Nose landing gear leg vendor material defect

**EFFECTIVITY****MODEL-R7****SERIAL NO:** 10196-10228**Synopsis:**

**Figure 2: 812601 Nose Landing Gear Weldment**

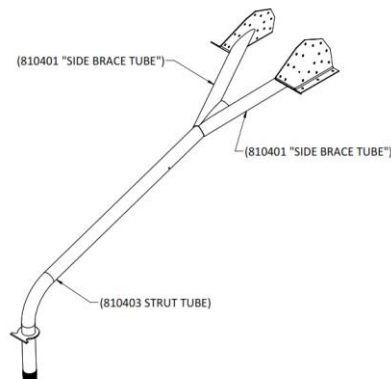
The portion of the weldment in question is the shorter, 810401 side brace tubes shown in Figure 2 (not the 810403 main strut tube). The 810401 tubes are supplied to Vashon Aircraft from a third party that performs the cope cut operation. Vashon Aircraft has discovered that the third party fulfilled an order with an unconfirmed percentage of parts made from material that does not conform to the 810401 drawing. The non-conforming material does not exhibit the necessary allowable strength requirements and is not heat treatable. While a certification of conformance and material certifications were supplied from the third party, non-conforming parts still entered our inventory. The weldments passed the heat treat quality check because the strength validation gets performed on the 810403 main strut tube.

Inspect the nose landing gear leg by following the instructions laid out in the "Method of Compliance" section. This inspection tests the 810401 side brace tubes for Rockwell C hardness (HRC). The hardness metric is proportional to heat treatment strength, so if the 810401 side brace tube does not register on the HRC scale (i.e. not heat-treated), then it is clear that the part is made from the non-conforming material.

- If either one of the 810401 tubes do NOT register on the HRC scale, then the part is non-conforming and the nose landing gear weldment needs to be replaced.
- If both 810401 tubes register on the HRC scale, then the part is conforming and does not need to be replaced.

**Figure 3: Detail A**

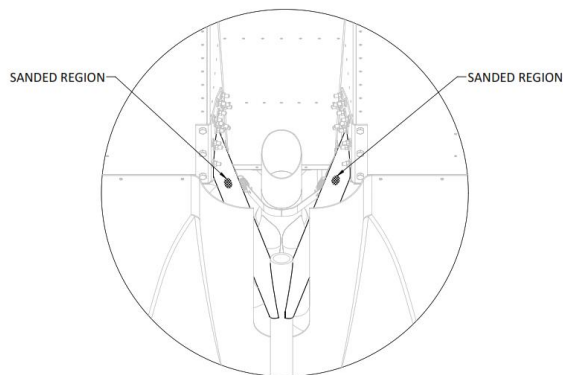
**Step 2:** Using a piece of sandpaper, sand off the white powder coat until roughly a ¼ inch circle of bare metal is visible in an accessible spot on the 810401 side brace tube. (see Figure 3).

**Figure 7:** HRC Test on Tube

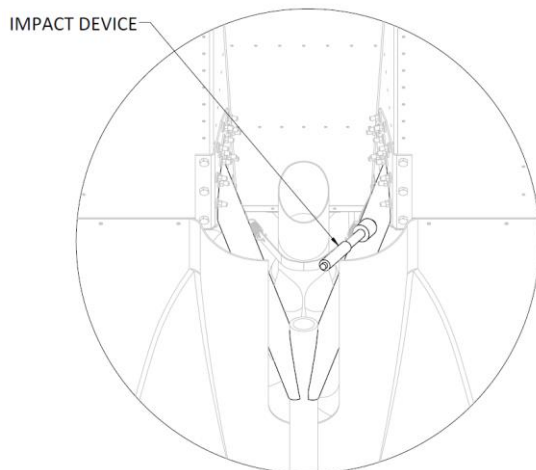
**Step 5:** Place the impact device base directly on top of the bare metal that was sanded. *NOTE: It is important that the axis of the device is placed perpendicular to the tube and that you and the device are stable during the test.* Push the release button on the top of the device. You will hear the plunger impact the tube and bounce back a few times. The display will then show the hardness reading. If it registers on the HRC scale, a number will be present. If it does *not* register, then a downwards arrow will be present with no number (see Figure 8).

**Step 6:** If the test registers on the HRC scale, then that tube can be considered conforming, and this process must be repeated for the adjacent 810401 tube on the weldment.

If either one of the 810401 tubes do not register on the HRC scale after testing multiple times, then the nose landing gear leg needs to be replaced. Contact Vashon Aircraft for parts procurement and install per the aircraft maintenance manual.
